TOWN OF NEWBURGH PLANNING BOARD TECHNICAL REVIEW COMMENTS

PROJECT: BJ'S WHOLESALE CLUB-NEWBURGH

REVIEW DATE: 30 MAY 2019 MEETING DATE: 6 JUNE 2019

Below please find our responses to a comment letter received from McGoey, Hauser & Edsall Consulting Engineers D.P.C., dated June 20, 2019 and a comment letter received from Creighton Manning, dated June 19, 2019. The comments have been repeated here for clarity.

TRUCK TURNING TRACKS

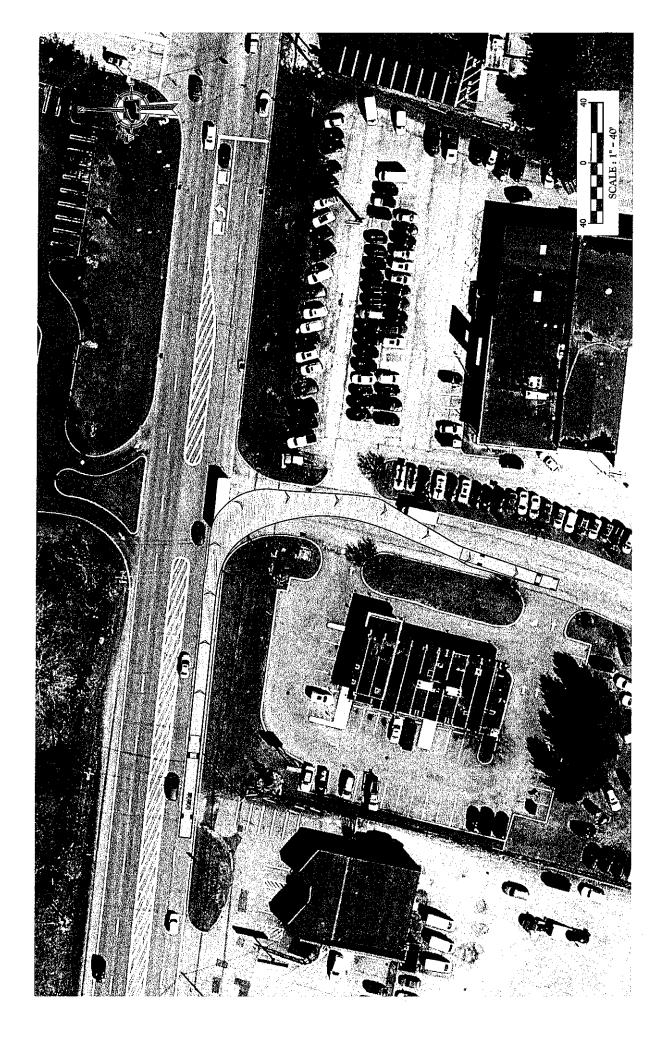
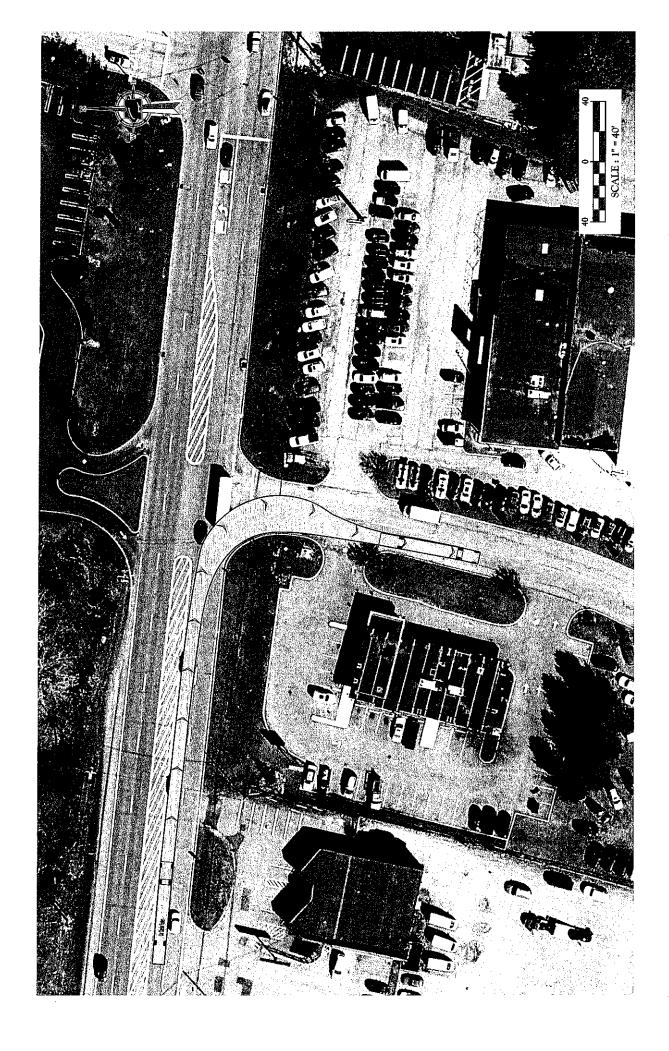
We generally concur with the mitigation proposed for the Route 17K/Auto Park Place intersection, which includes restriping the median to provide a two-way left turn lane and restriping Auto Park Place to provide separate left and right turn lanes. We note that the approach of Auto Park Place is currently about 16 feet wide, so restriping will require narrowing the southbound lane leaving the intersection. Given the volume of truck deliveries to the site and car loaders to the adjacent dealerships, truck turning movements should be reviewed and adequate loading/unloading activities currently take place on Unity Place and Auto Park Place and how it will be accommodated with the additional traffic generated by the proposed development.

We would expect trucks originating from the I-87 northbound and from the west on Route 17K to use Unity Place for access to Auto Park Place. Attachment 3 contains the truck turning tracks for right turns onto Auto Park Place from Route 17K. As identified, under existing conditions, a car carrier turning onto Auto Park Place must track into the opposing traffic whether from the inside or outside Route 17K travel lane. As such, we suggest directing all truck deliveries from the west destined to Auto Park Place to use Unity Place.

UTILITIES PLAN

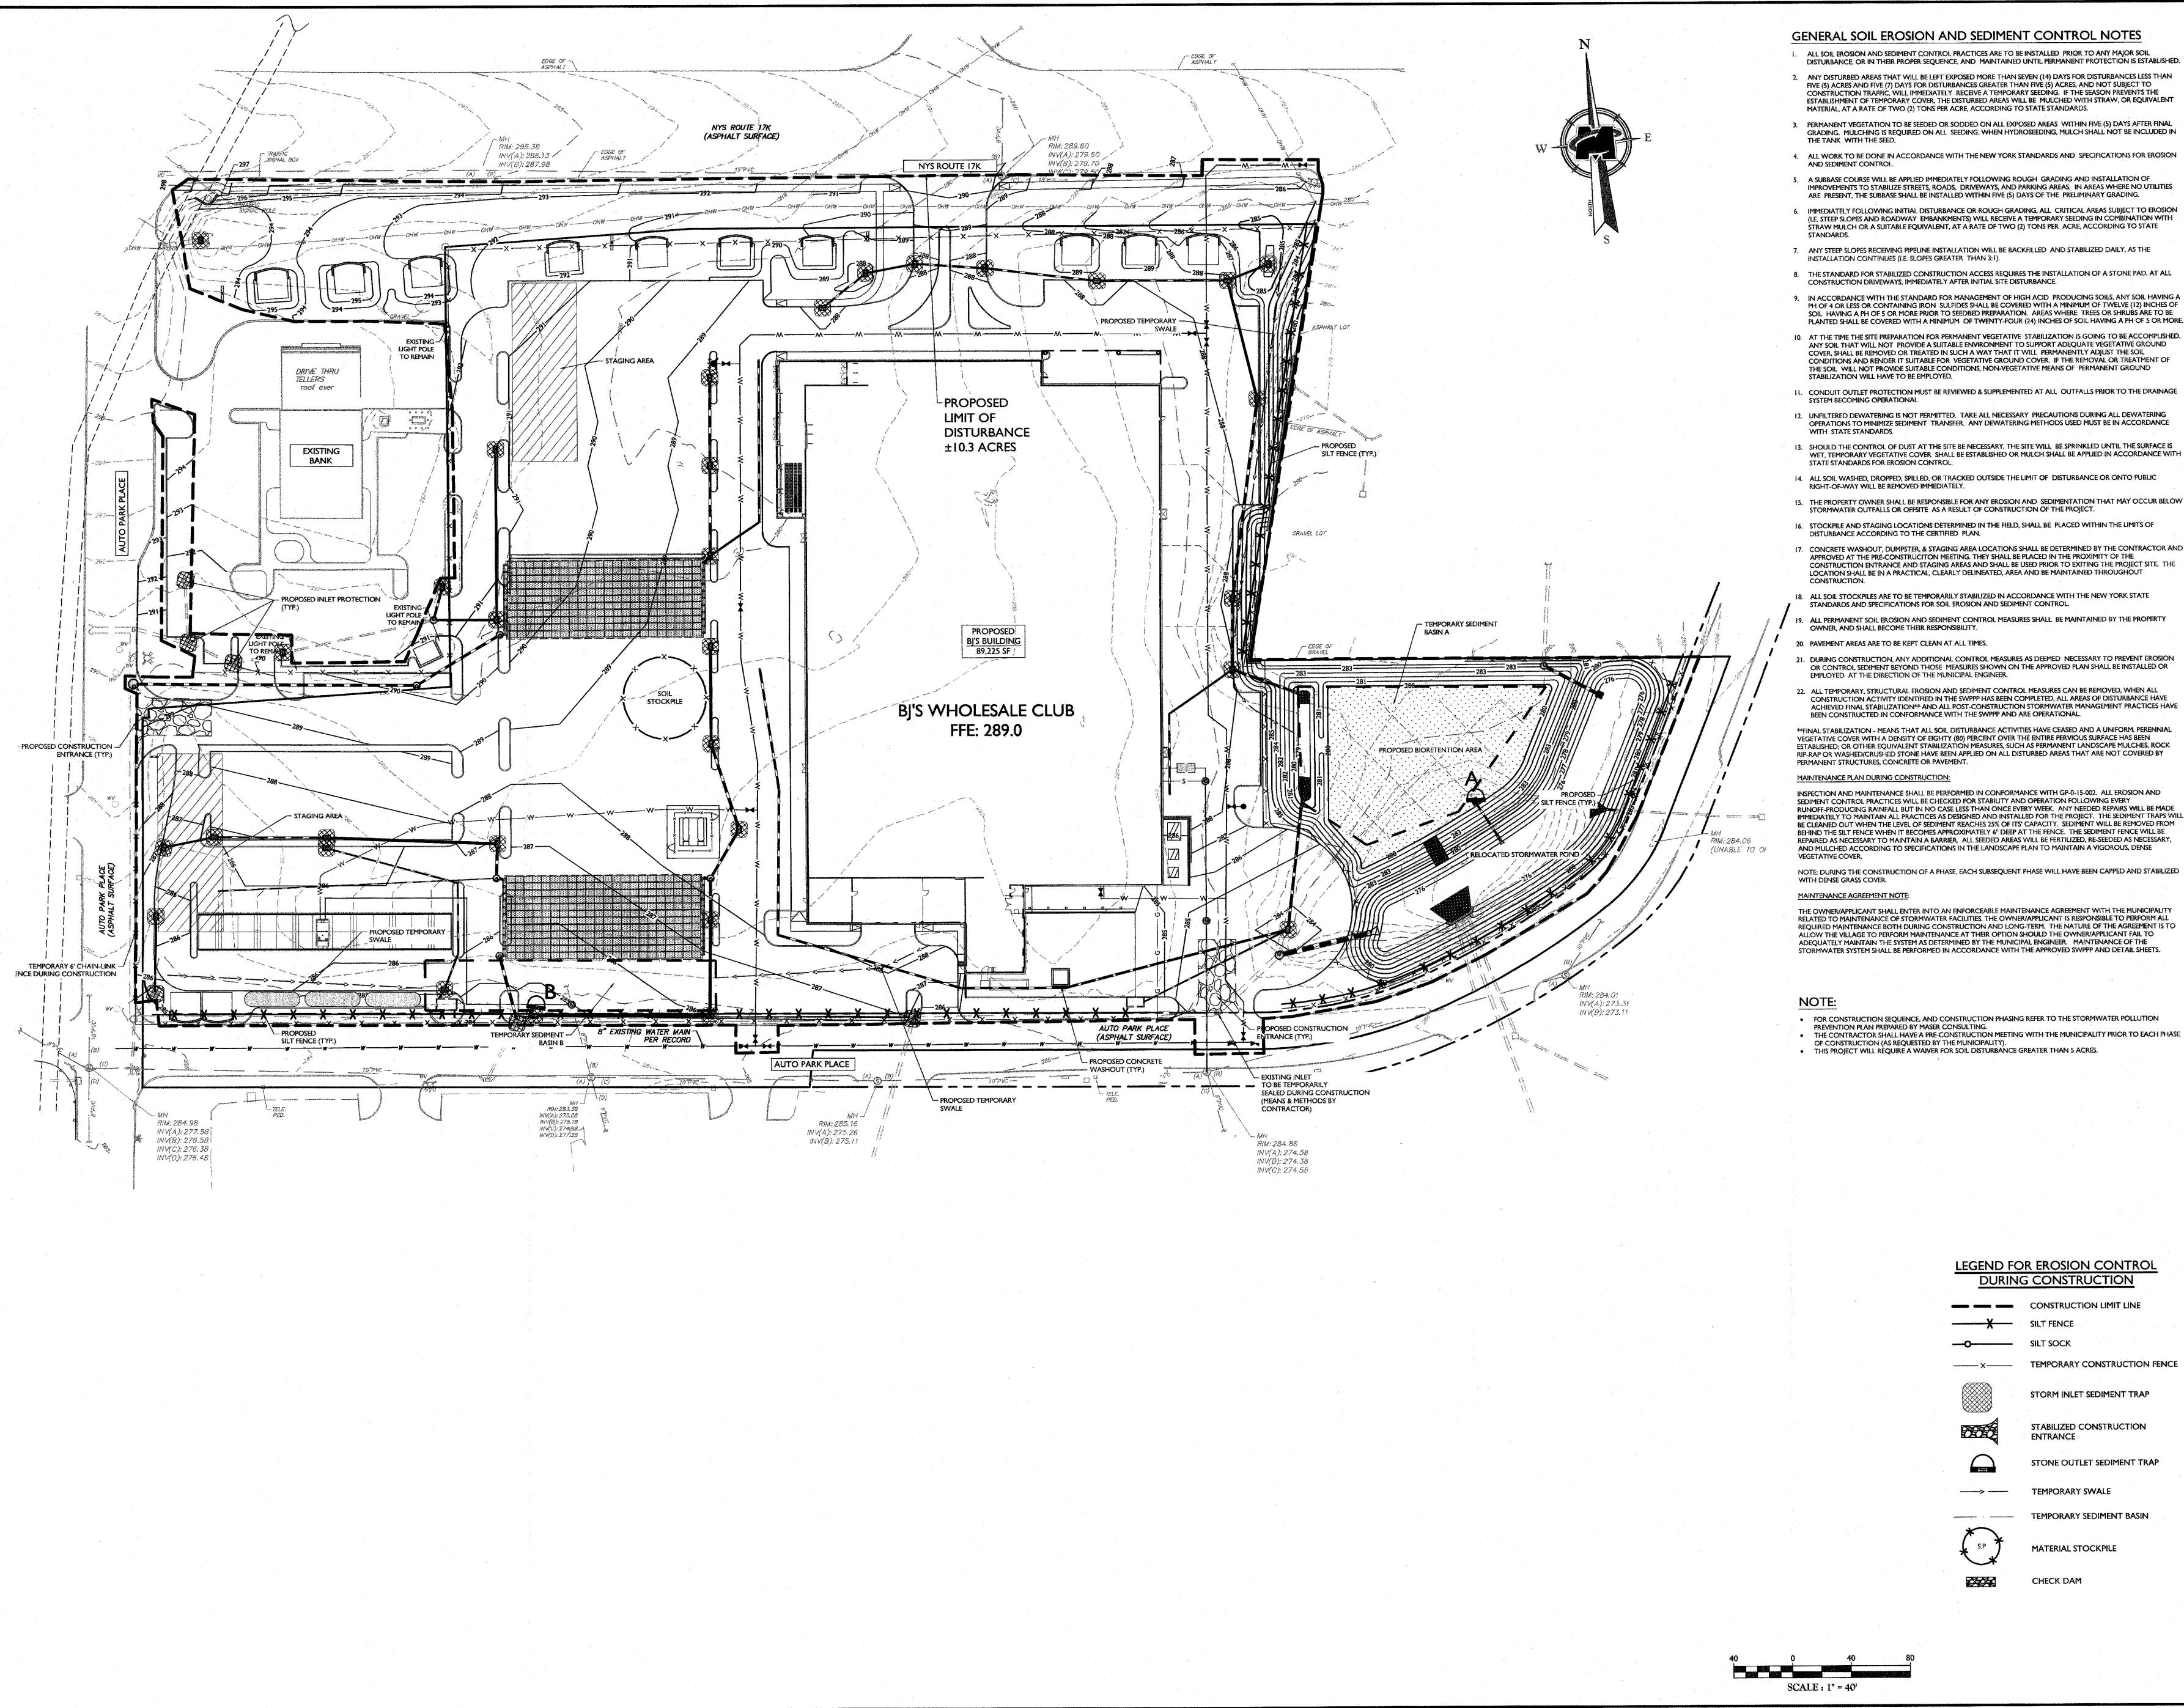
Comment 11: Potable water service and fire service line must be connected such that when fire service is turned off potable water to the structure is turned off, typical details should be provided.

Response 11: This connection type has been depicted on the utility plan. Additionally, a detail has been added to the plan.

SEWER CONNECTION TO EXISTING MANHOLE DETAIL

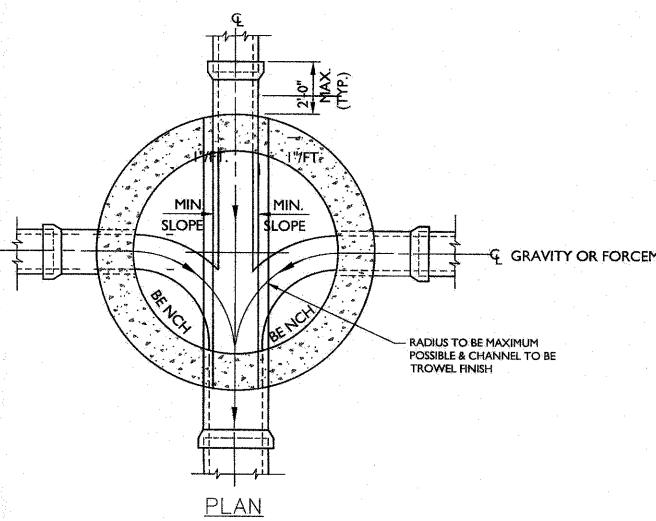
- Response 19: Note has been added as requested.
- Comment 20: All connections to existing Town of Newburgh manholes must be via core drilling. Detail depicting modification to existing manholes and identifying core drill should be provided.

Response 20: A note has been added to the "sewer connection to existing manhole detail" stating connection to the exiting manhole is to be done with a core drill.
